2000-3 Arapaho Road

Arapaho Rd Drainage Meeting 8-12-99

RE: Arapaho Road - Addison, Texas

Re: Arapaho Road

PAVING PLAN & PROFILE
STA. 50+00 TO STA. 55+00
ARAPAHO ROAD
ADDISON ROAD TO DALLAS NORTH TOLLWAY
TOWN OF ADDISON, TEXAS
Hull-Zollars, Inc./Consulting Engineers
Dallas, Fort Worth, Houston, Phoenix, Austin

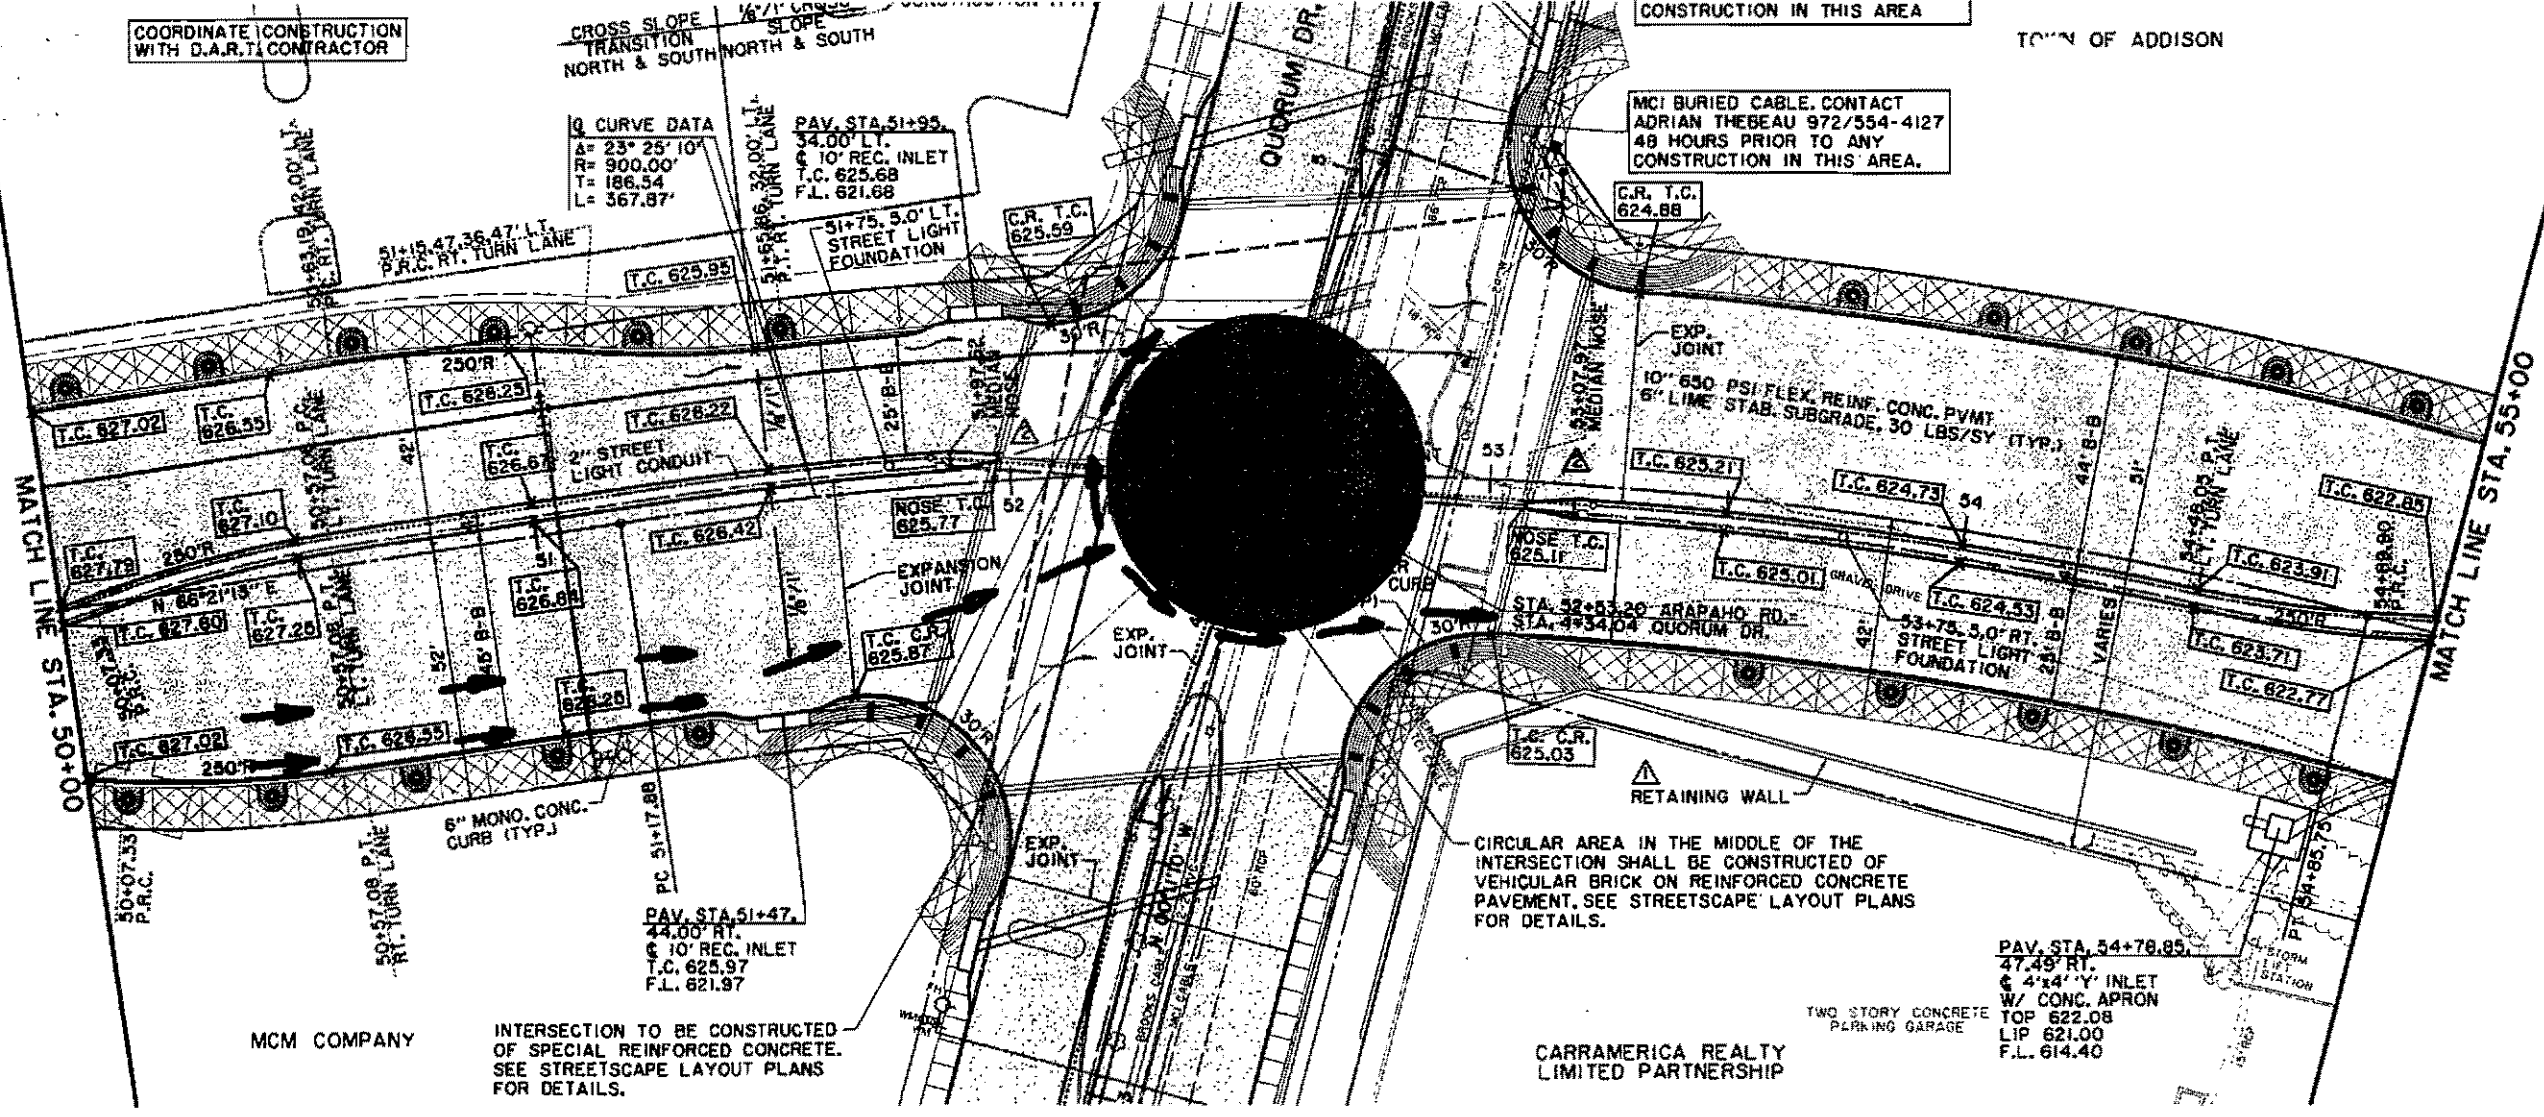
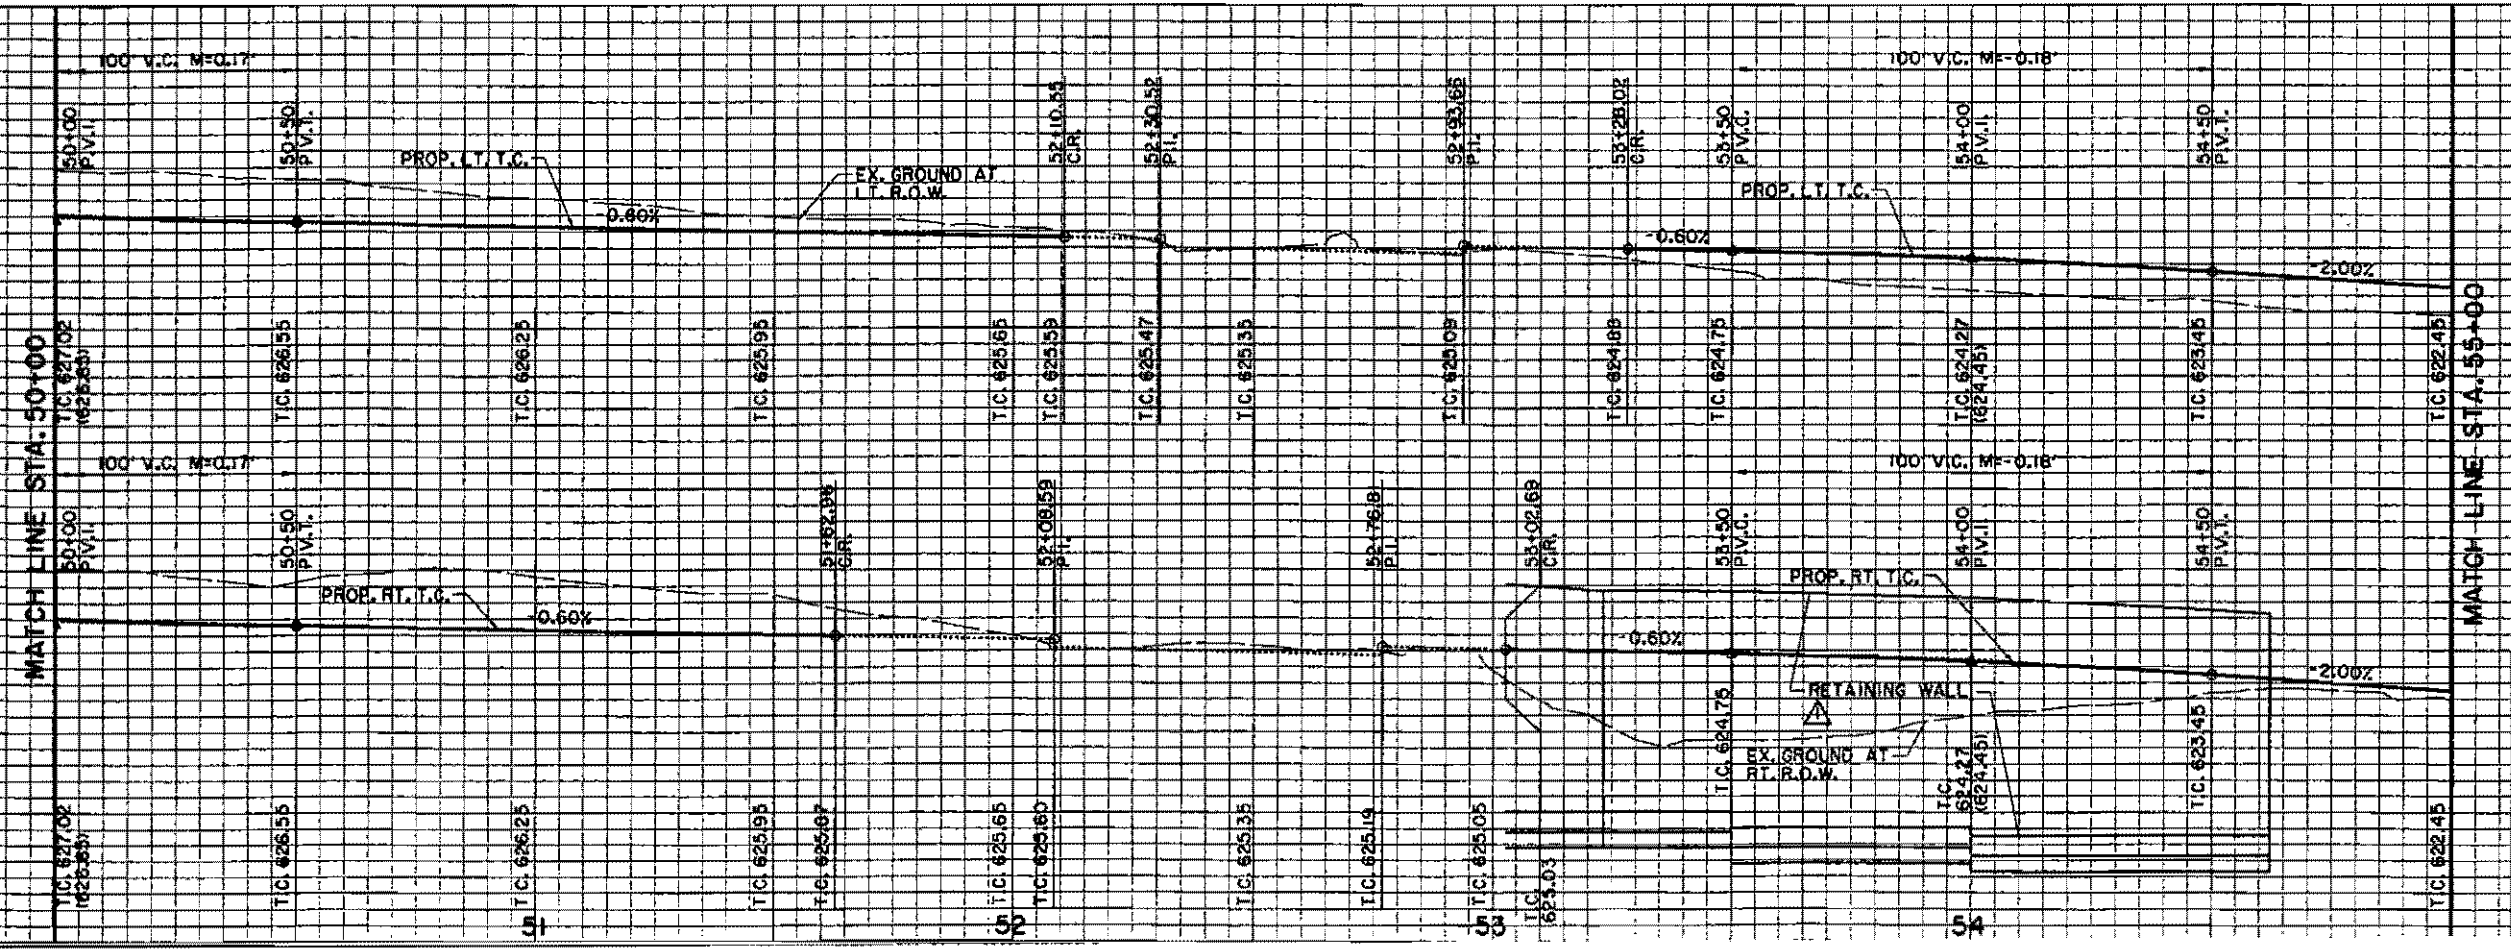
They do not think the intersection was built as per plans. Plan sheet P-5, Sta 50+50 calls for $\frac{1}{8}$ " per foot cross slope, North and South thru the intersection with Quorum, that extends across Quorum

I made a site visit to the Arapaho Road project site on Friday, May 28, 1999 to look at the progress of the construction and observed an irregular drainage pattern at the southwest corner of Arapaho Road and Quorum Drive. As we have discussed, on a previous occasion and this morning, you expressed concern that the inlet at paving station 51+47 was not picking up the water draining to the east along the south curb of Arapaho Road before crossing the Quorum Drive intersection. On Friday, I observed the same scenario.

As you stated this morning, on Friday the phone company had pumped water out of a trench or manhole and it was draining along the gutter in question. The amount of water running down the street was just enough to delineate the drainage pattern and highlight the problem. The water was draining along the south gutter and the pavement joint between the east bound right thru lane and the right turn lane with an apparent high and dry spot in the right turn lane. As the water neared the inlet at paving station 51+47, it began to drain in a northeasterly direction towards the center of the circle in the Arapaho Road / Quorum Drive intersection. When the water reached the outer edge of the brick pavers, the water split and drained to the north and east around the brick circle. The easterly flow eventually crossed the intersection and rejoined the south gutter. The northerly flow crossed the centerline of Arapaho Road and continued around the circle in a northeasterly direction. I have enclosed a copy of Paving Sheet P-5 with the drainage patterns that I observed marked in blue.

Arapaho Road was designed with a 1/8" per foot cross slope in this area. Water should not be draining away from the curb and certainly not across the ridgeline at the centerline of Arapaho Road. In this area the water should be draining along the south curb and across the Quorum Drive intersection in the valley gutter. Based on my observations, it appears the intersection is built too flat. Further investigation by the Contractor regarding "As Built" elevations on the pavement should be initiated. After the investigation, alternative solutions can be evaluated.

As-built of what was built is needed. H.Z. will send tape to Robt Weber with a letter requesting an as-built.
